**To:** Matt Scharf  
**From:** Jeff Walton, Associate Planner; 910-341-3260  
**CC:** File; Charlie Cazier  
**Date:** 10/15/2013  
**Re:** Planning Review

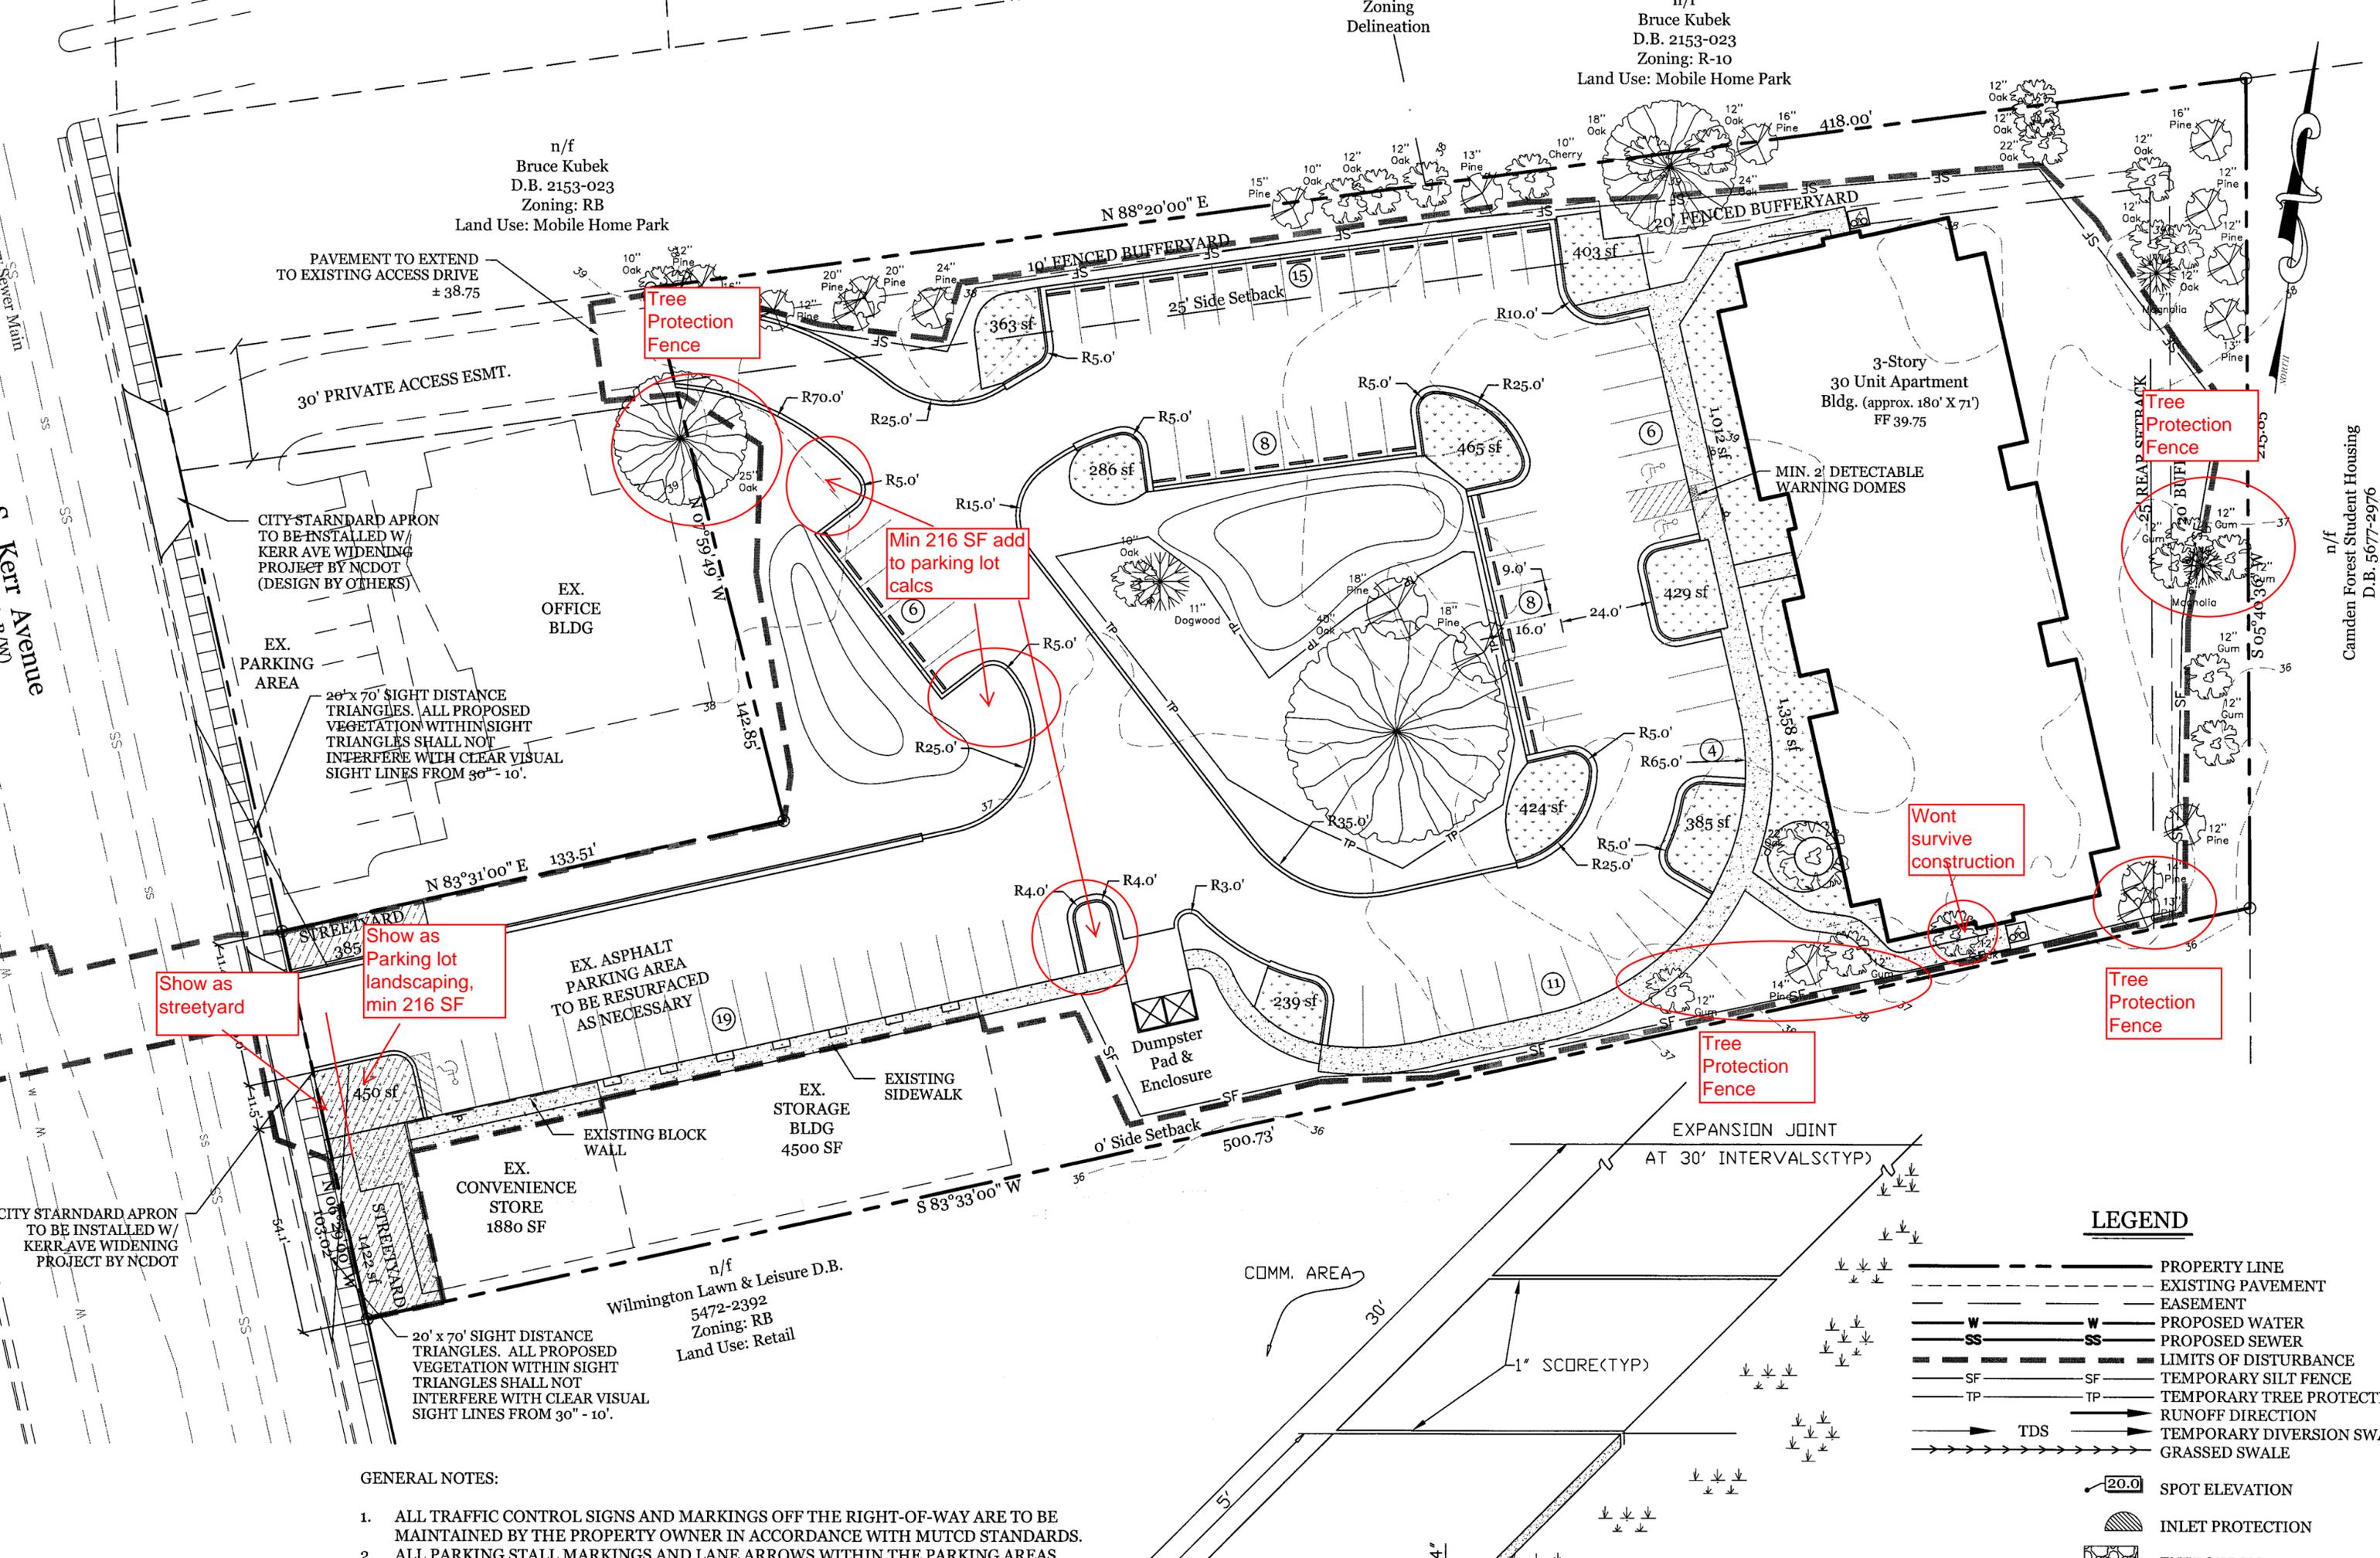
- Sec. 18-462 (d) (5): Show locations, dimensions and square footages of required bufferyards, streetyards, foundation plantings and parking lot landscaping.
  - See Notes on attached redline of your plans.
  - Show provided streetyard in data table.

Min 216 SF add  
to parking lot  
calcs

Tree  
Protection  
Fence

Wont  
survive  
construction

Show as  
streetyard

Show as  
Parking lot  
landscaping,  
min 216 SF
